# Development Plan Submissions Gibson Street Leongatha

**Re: Development Plan, 77 Gibson St LEONGATHA**

RE: Development Plan at 77 Gibson Street, Leongatha (DP09)

**Road Hierarchy Plan**  
Shingler Street, Leongatha  
"Shamrock Springs"

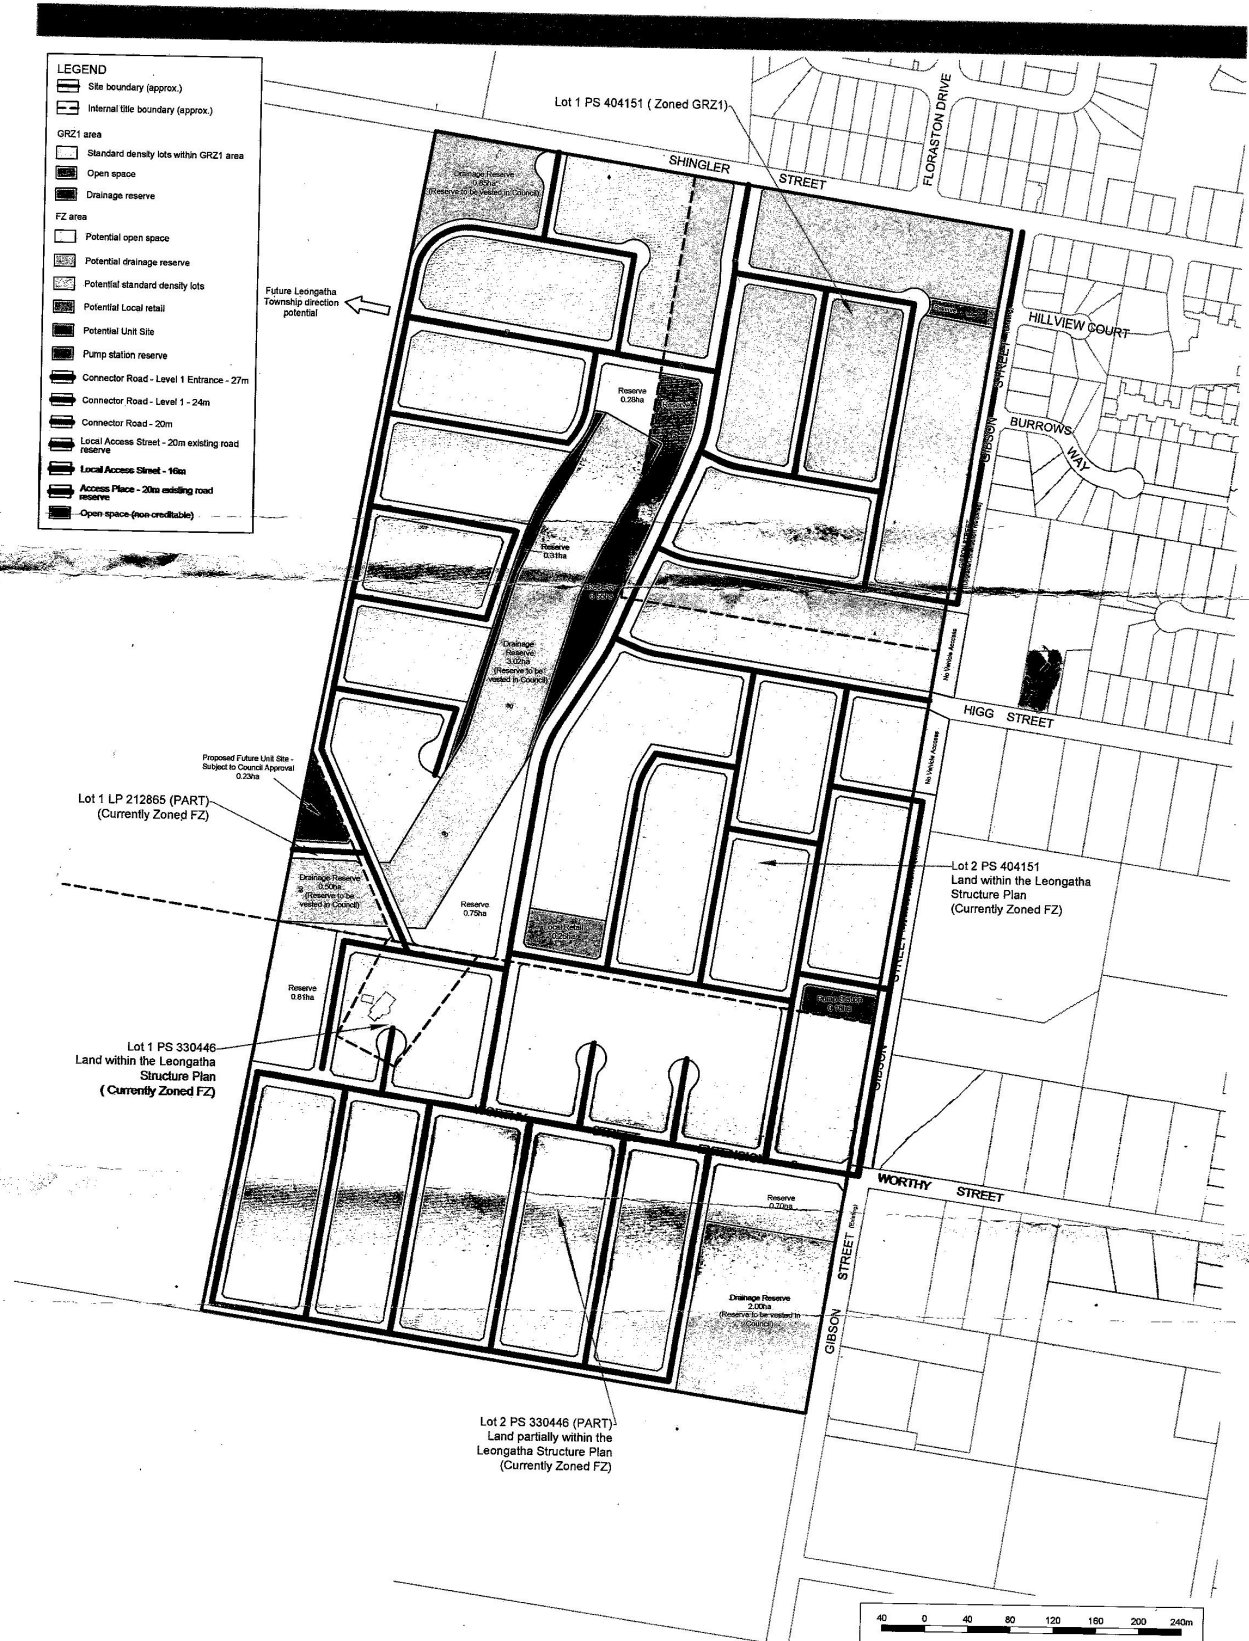
I am a owner/resident of [REDACTED] which is at the end of the street (**currently a no through road**) and we were horrified to find out that our street would change to a through street leading into the proposed development.

Being at the end of a no through road/street has been a bonus as we have young grandchildren who play out in the street as there is very little traffic that comes to our end of the street making it ideal for them to ride bikes and play ball games in safety. If you connect up the street that will all change making it dangerous for all the children in the street with the increased traffic within the area.
